# TECHNICAL BULLETIN

NO. 407-97-7

**MODELS AFFECTED:** 407

**SUBJECT:** THROTTLE GRIP FRICTION, INSPECTION AND MODIFICATION OF.

**Figure 1. Setscrew replacement**

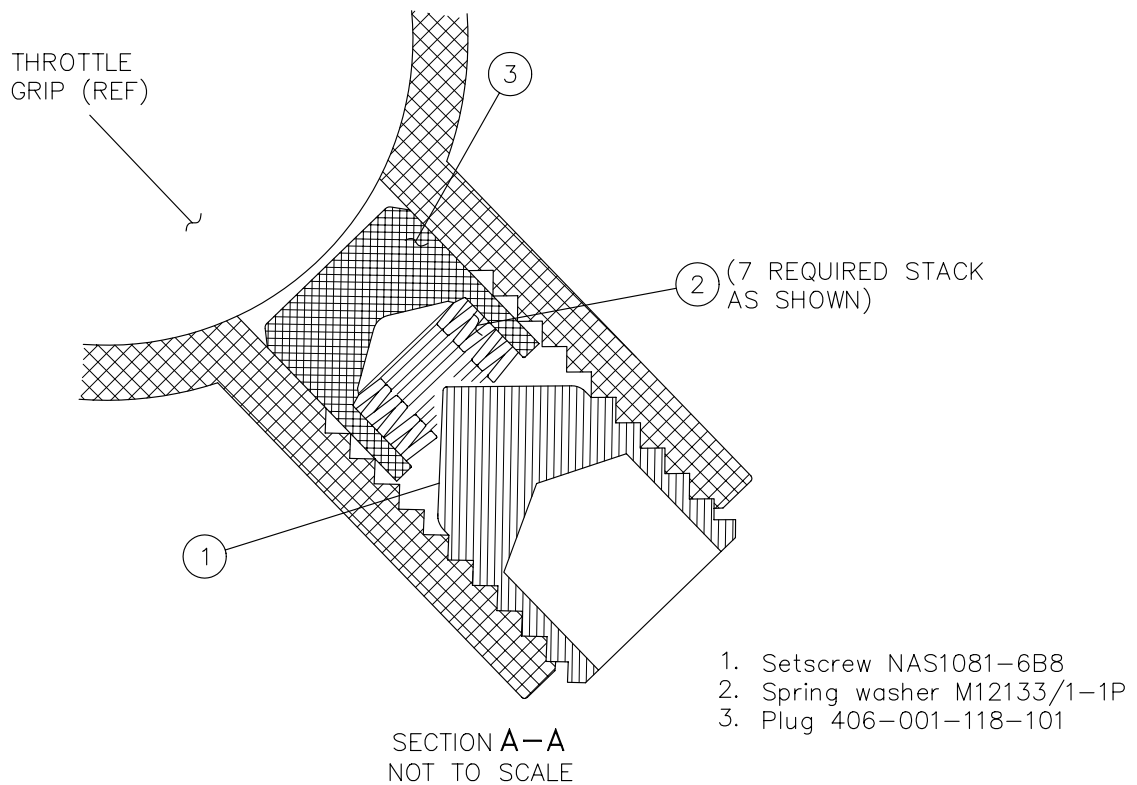
**DESCRIPTION:** Bell Helicopter has found that some throttle friction assemblies setscrew may not have the self-locking feature. This difference can permit the setscrew to turn freely and create a loss of throttle friction.

1. With the use of a 3/16 inch allen key, remove the throttle friction adjustment setscrew (1, Figure 1). Remove the spring tension washers (2), and the plug (3).
2. Examine the setscrew (1) to see if there is a teflon locking element.

3. If the setscrew (1) has a locking element, install the removed components in the reverse order of step 1 and go to step 5 (Figure 1).
4. If the setscrew has no locking element, replace the setscrew (1) with a new self-locking setscrew.
5. Do the throttle grip friction adjustment as follows:
  - 5a. Tighten the throttle grip friction setscrew (1) until a slight friction is detected when the throttle grip is rotated.
  - 5b. Install a suitable length of cord (C-471, BHT-ALL-SPM) around the throttle grip and attach a fish scale to the cord.
  - 5c. Pull the fish scale to turn the throttle grip from the cutoff position to the full throttle position. Make sure that the fish scale indicates a maximum of  $10 \pm 0.5$  pounds

(4.5 ± 0.23 Kg) after the initial breakaway force. The operation must be smooth throughout the entire range. Carefully adjust the throttle setscrew as required to get the correct value.
